Addendum No. 02

Subject: Julia R. Masterman High School – Elevator
Replacement SDP Contract No. B-069C 2018/2019

This Addendum dated February 24, 2021 shall modify and become part of the Contract Documents for the work of this project. Any items not mentioned herein, or affected by, shall be performed strictly in accordance with the original documents.

NO.	DATE	REVISIONS	INT.	SCHOOL DISTRICT OF PHILADELPHIA MASTERMAN HIGH SCHOOL				TITLE: ELEVATOR REPLACEMENT		
								JOB:	DRAWN BY:	CHECKED BY:
								B-069 C	FJR	BAM
				VALLEY FORGE, PENNSYLVANIA				DATE:	REF. DWG.	DRAWING NO.
								02.24.2021	E-102	SK-1

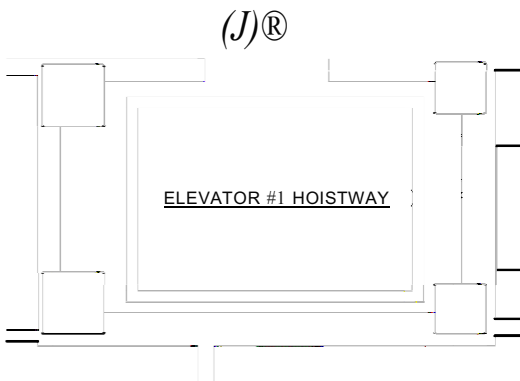
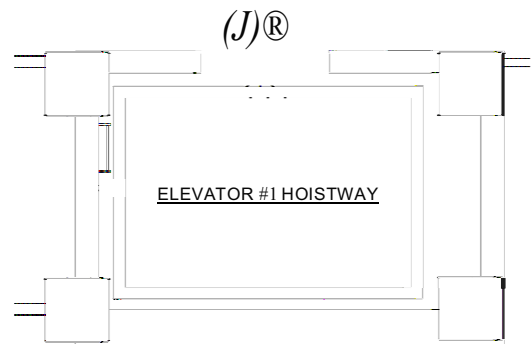
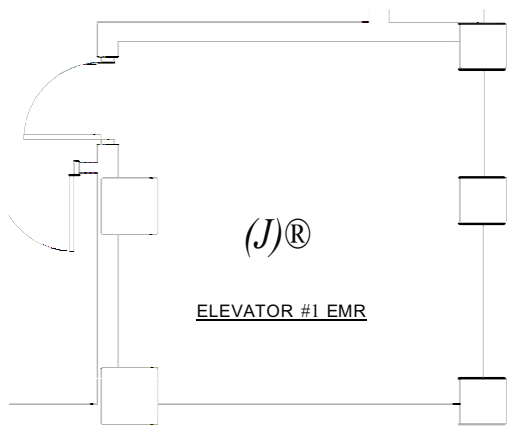
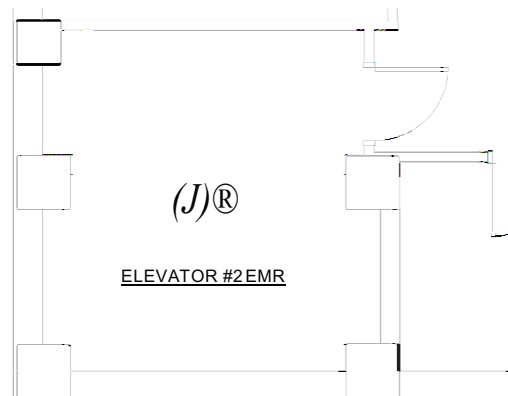
Detail 3 on Drawing E-103 calls to connect elevator recall modules to an existing fire alarm addressable loop. The fire alarm is not an addressable system, it is an old Couch, 120v system. The addressable modules and elevator recall cannot be connected to this system. Drawing notes tell us to verify existing lobby smoke detectors, elevator & machine room heat detectors, they do not exist. How do we proceed to get an elevator code compliant fire alarm system?

1. PROVIDE (1) ELEVATOR RECALL CONTROL AND SUPERVISORY PANEL (ERCSP) IN BUILDING ENGINEER'S OFFICE. INTEGRATE ERCSP WITH EXISTING FIRE ALARM CONTROL PANEL FOR SUPERVISORY, TROUBLE, AND ALARM SIGNALS. PROVIDE A TOTAL OF FIFTEEN (15) CEILING/WALL-MOUNTED (FIELD VERIFY) SMOKE DETECTORS-ONE AT EACH ELEVATOR LANDING, ONE IN EACH WITH BUILDING ENGINEER). PROVIDE ALL CONDUIT AND WIRE REQUIRED FOR THESE SYSTEMS. ELEVATOR

MACHINE ROOM, AND ONE AT THE ERCSP IN THE BATTERY & SWITCHBOARD ROOM (COORDINATE EXACT LOCATION

- **Response:** Provide an Elevator Recall Control and Supervisory Panel (ERCSP) and Integrate that panel with the existing Fire Alarm system. Provide fifteen (15) smoke detectors to support the new elevator system. Integrate these smoke detectors with the new ERCSP. Refer to attached sketches SK-1, SK-2, SK-2.1, and SK-2.2.

E-102: Add Keyed Note #11: "Provide (1) Elevator Recall Control and Supervisory Panel (ERCSP) in Battery & Switchboard Room. Integrate ERSCP with existing fire alarm control panel for Supervisory, Trouble, and Alarm Signals. Provide a total of fifteen (15) ceiling-mounted smoke detectors – one at each elevator landing, one in the elevator machine room, and one at the ERCSP. Provide all conduit and wire required for these systems."

E-102: Add smoke detector to elevator machine room on plans #5 & #7. Add keynote indicator #11 at this smoke detectors.

@.  TRICAL ONE LINE DIAGRAM - NEW WORK

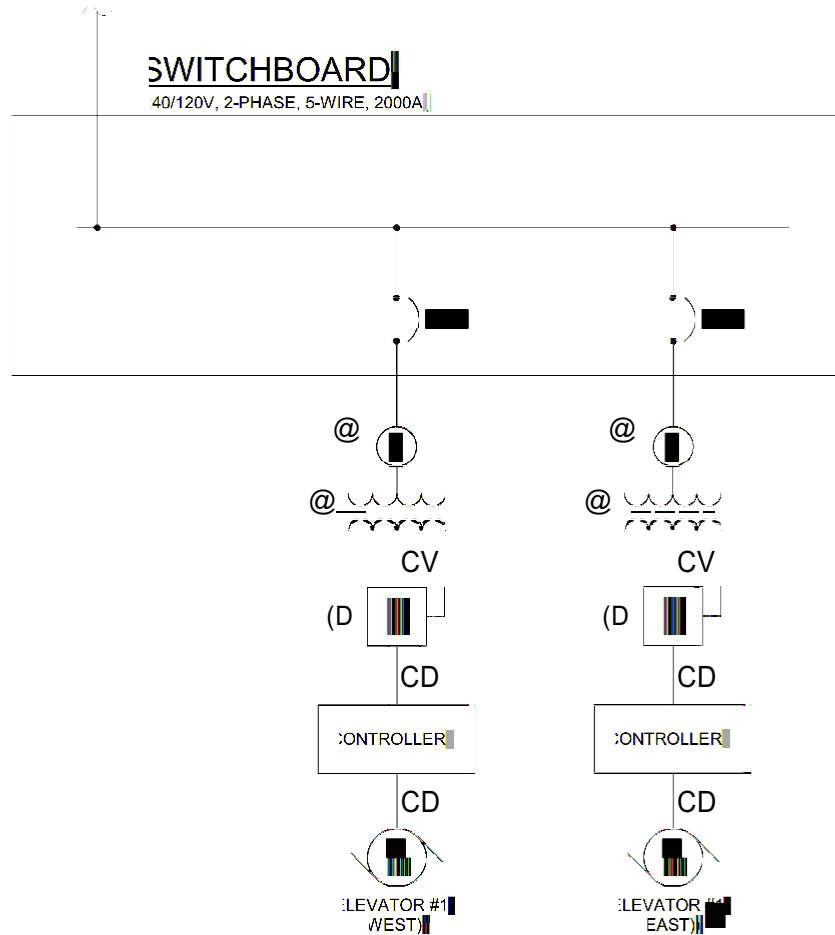
Detail 2 on drawing shows a 2 phase, five wire, 120/240v Main Distribution Panel with three pole breakers feeding elevators?? The existing elevator service is two phase (picture attached). How do we connect the two-phase service to the new three phase elevators?

- **Response:** Existing breakers are 4 pole. Provide (2) new Scott-T transformers. Connect existing elevator feeders to new Scott-T transformers; modify/extend existing feeder as required. Refer to attached sketch SK-3.

1. CONDUCTORS/CONDUIT BY ELEVATOR CONTRACTOR.
2. 3 #2, 1 #8 GRD, IN 1-1/2" C.

1. 100A, 240V, 3 POLE SHUNT TRIP FUSED DISCONNECT SWITCH PER SPECIFICATION SECTION 26 28 16.17.
2. CONNECT EXISTING ELEVATOR FEEDER TO NEW "SCOTT-T" TRANSFORMER; MODIFY/EXTEND EXISTING FEEDER AS REQUIRED, NEW WIRING TYPE/SIZE TO MATCH EXISTING.
3. PROVIDE NEW "SCOTT-T" TRANSFORMER: 37.5 KVA, 240V, 2 PH, 4W PRIMARY X 240V, 3PH, 3W SECONDARY.
